ZONING PLAN

KROGER FUEL CENTER – N341

Re: Kroger Fuel N341 – 2410 Stringtown Road
Special Use Submittal – Fuel Station Use – Application #201304290016

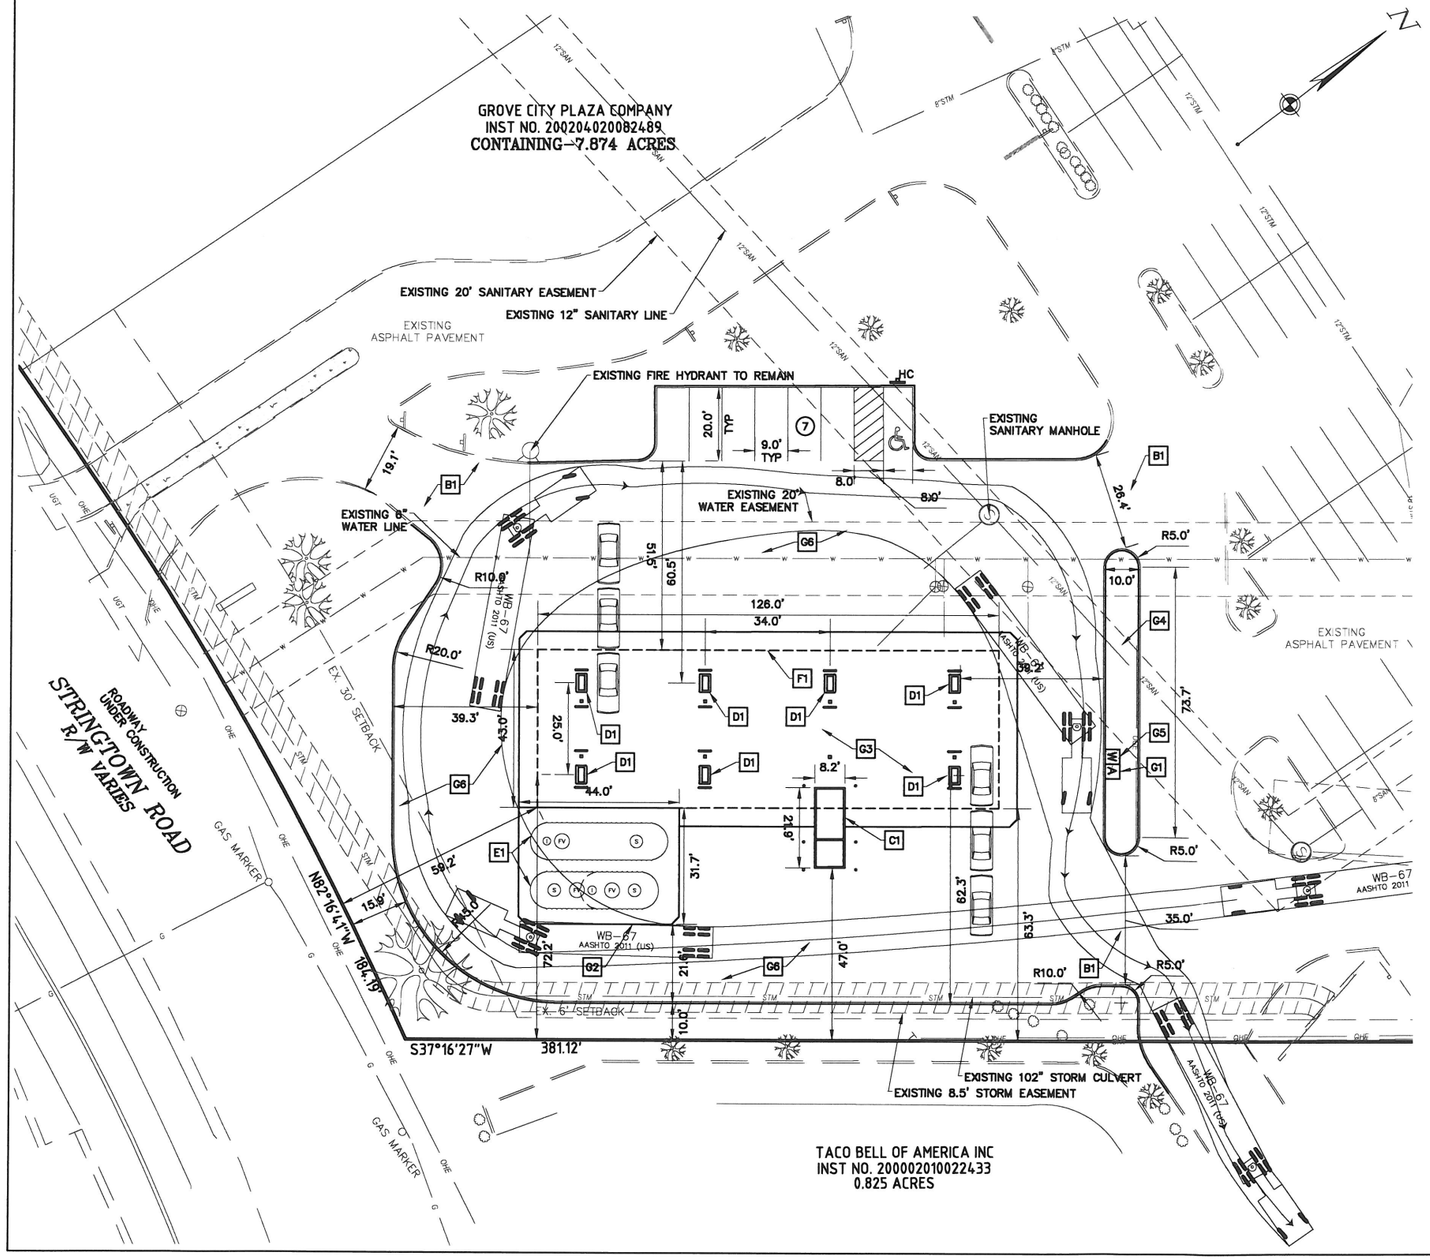
1. Dimensions for the canopy in note F have been corrected as requested to match the dimensions marked on the site plan.

2. The proposed height of the canopy is 19'-0" and has been noted on the site plan.

5. Parking spaces have been revised to meet zoning code requirements as requested. The handicap parking space has been revised to be van accessible as requested.

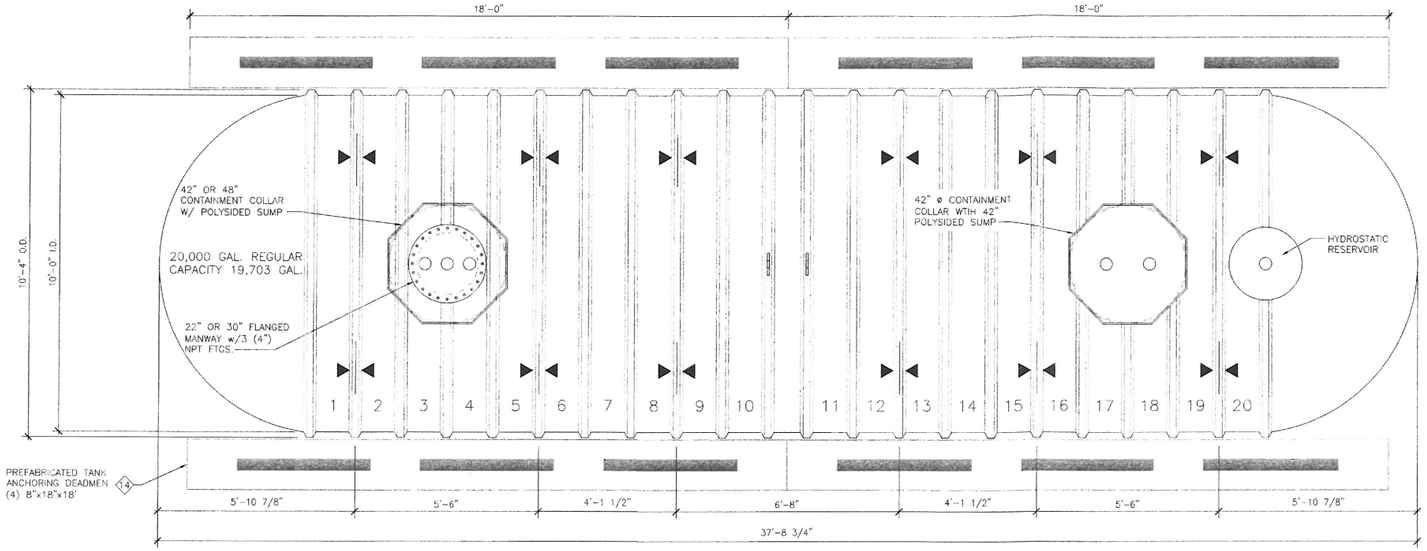
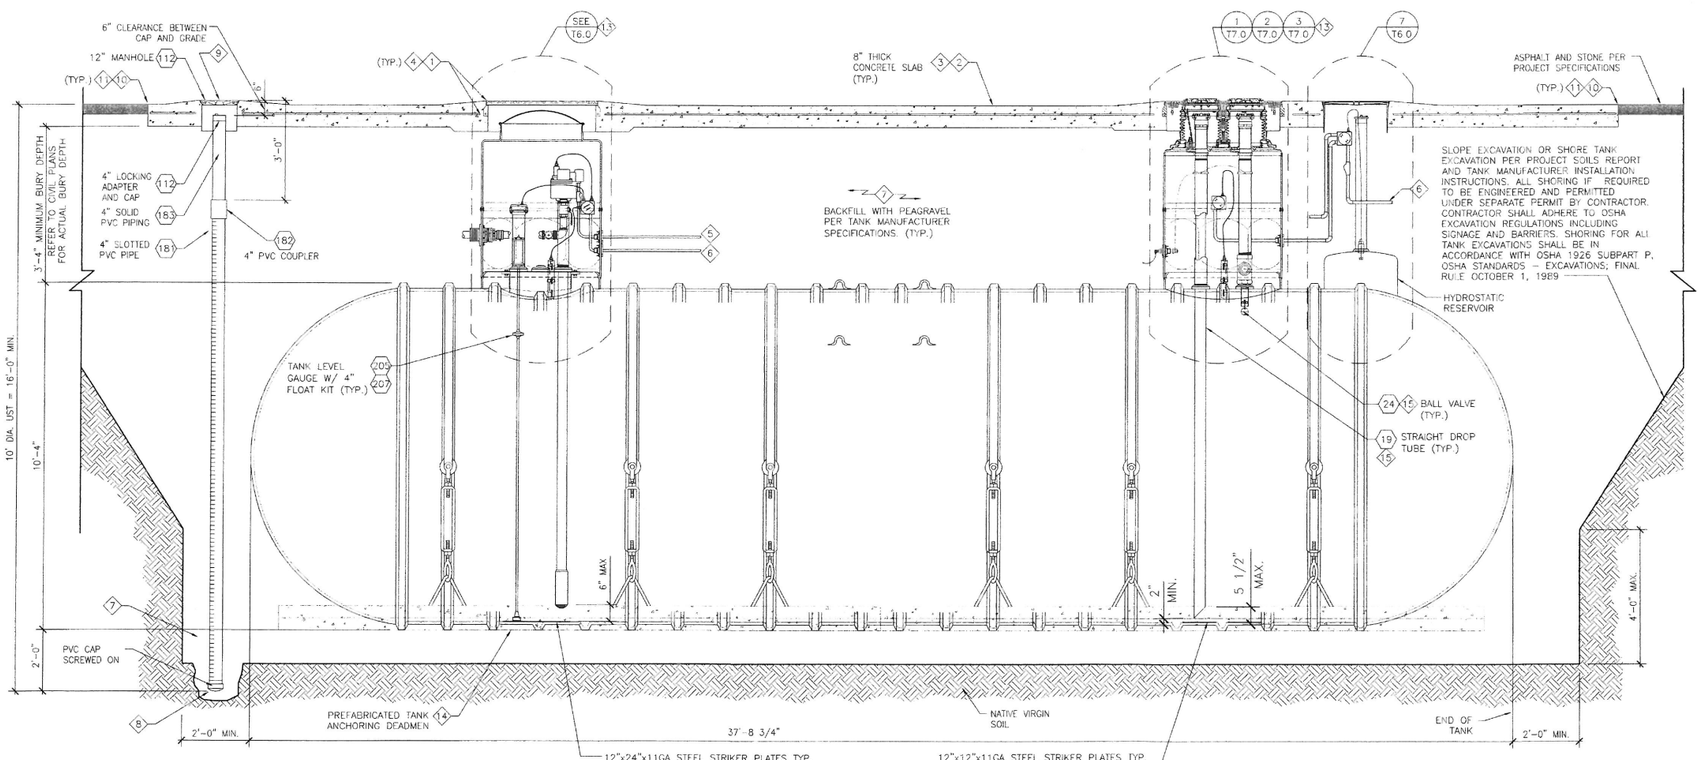
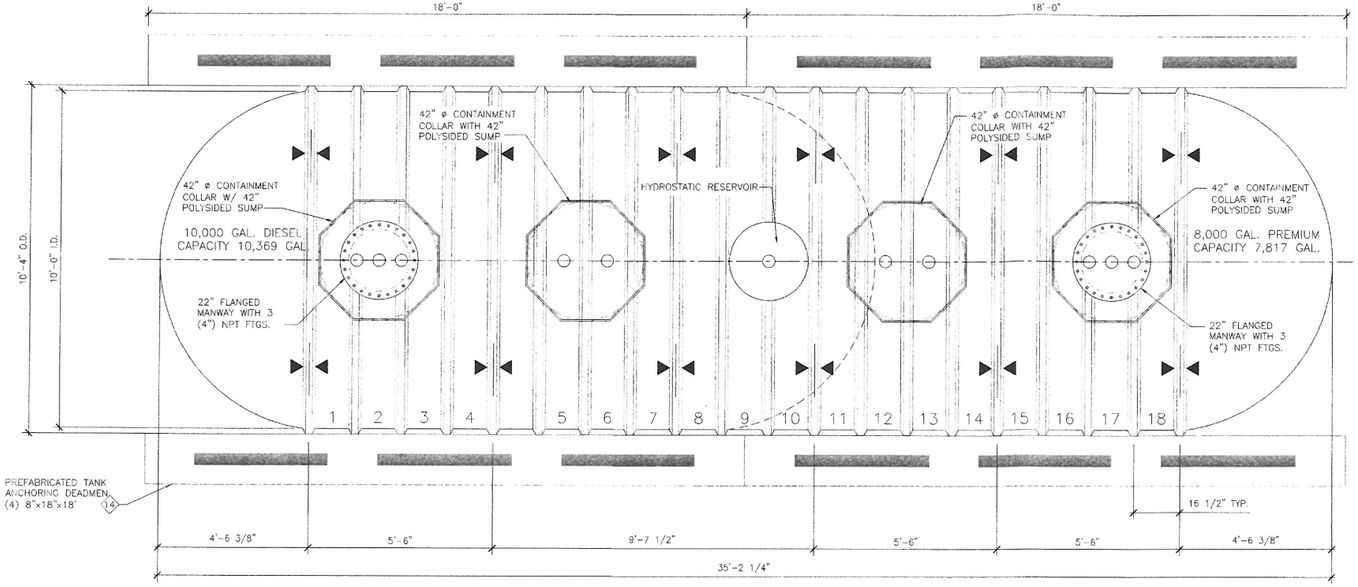
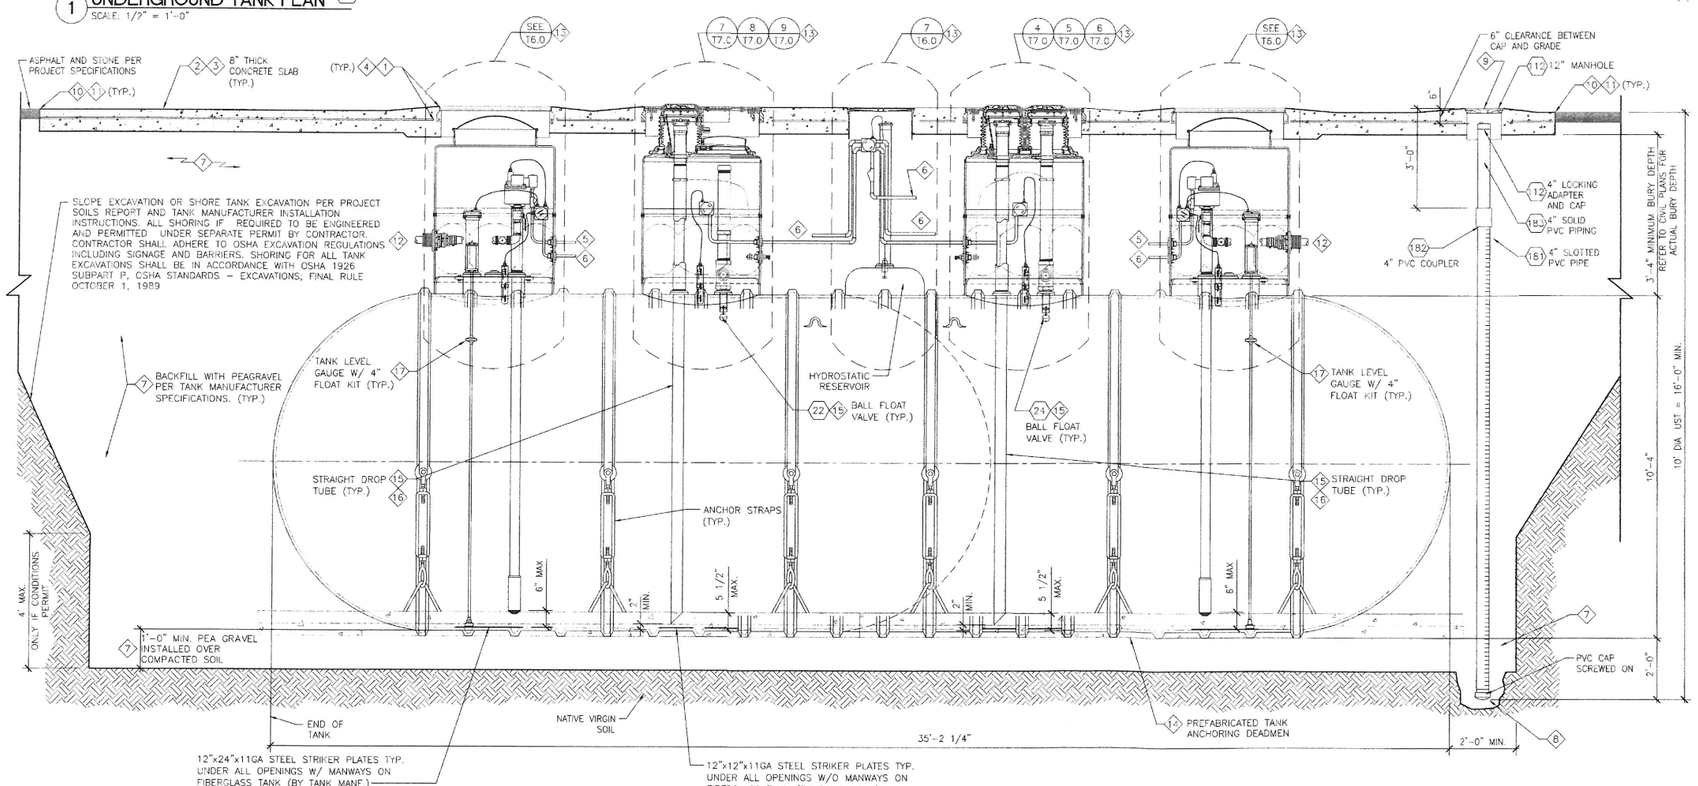
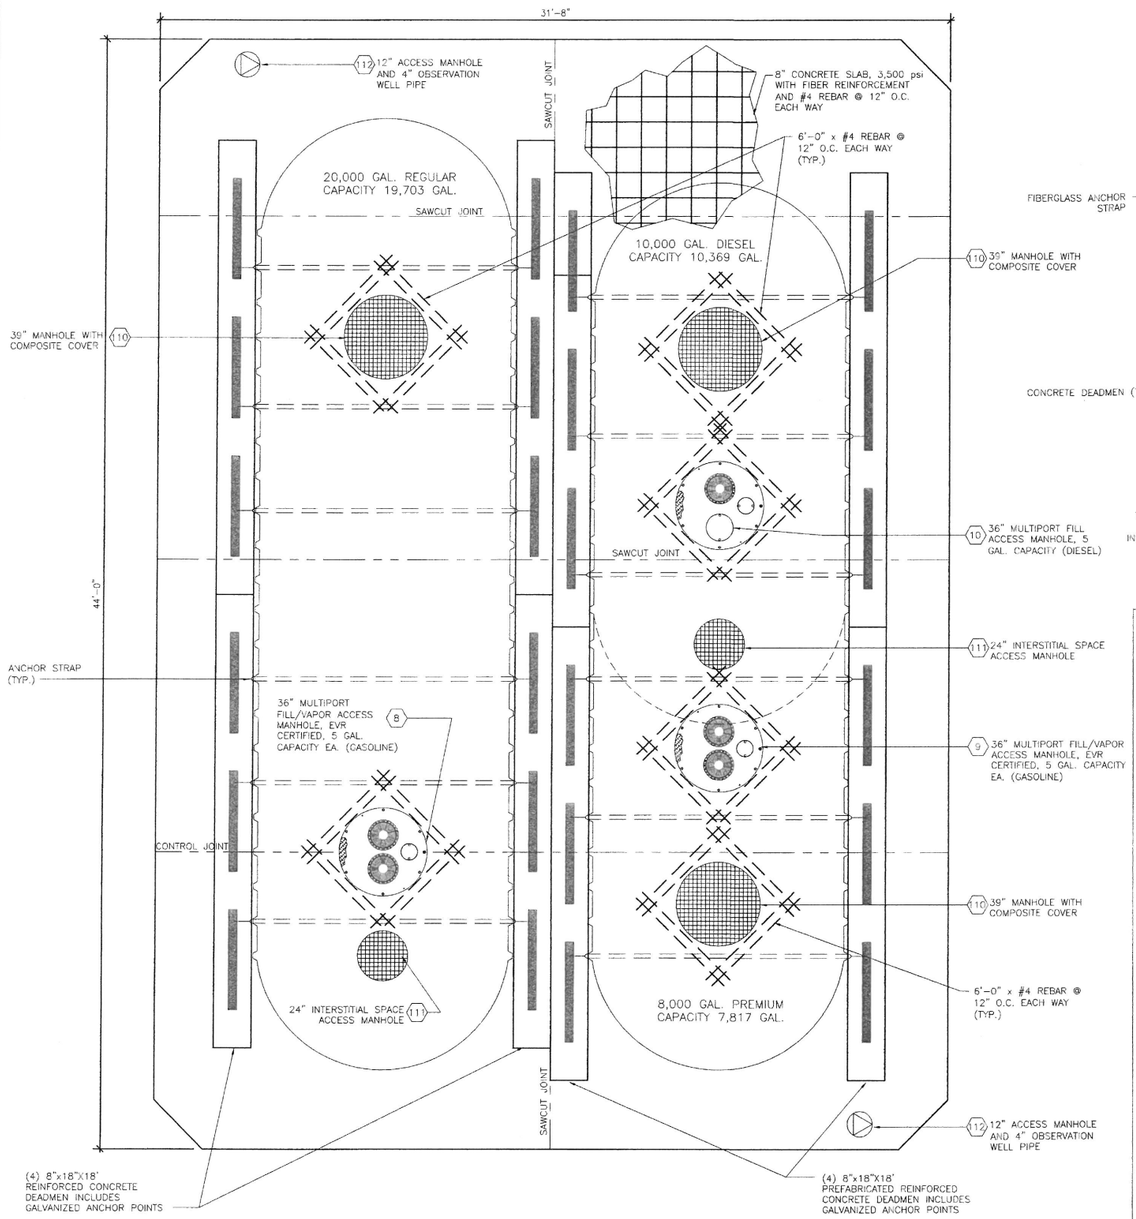
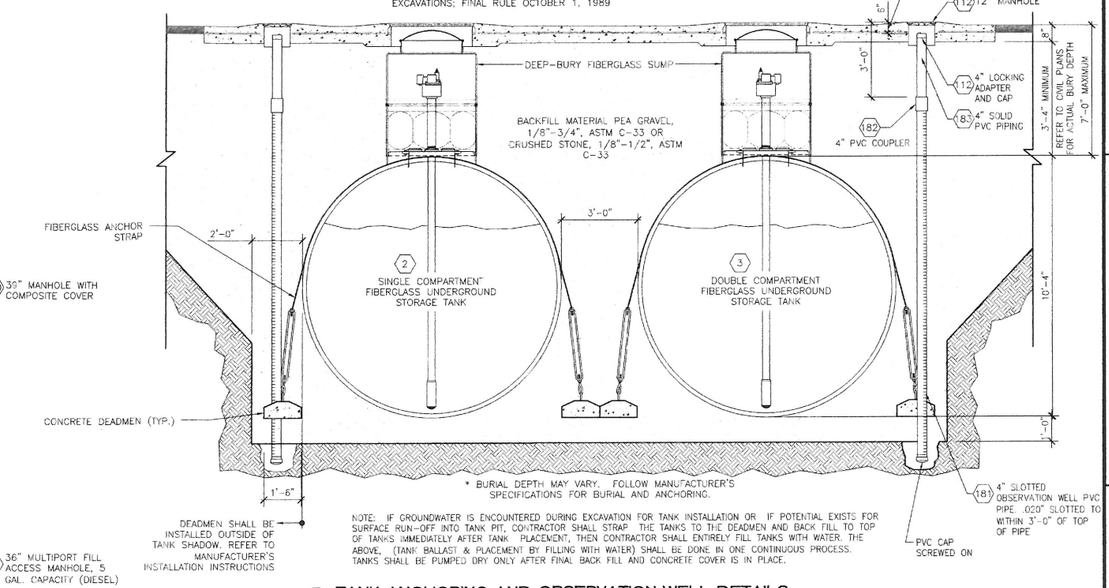
4. Additional details for the underground tanks have been included with this plan submittal as requested.
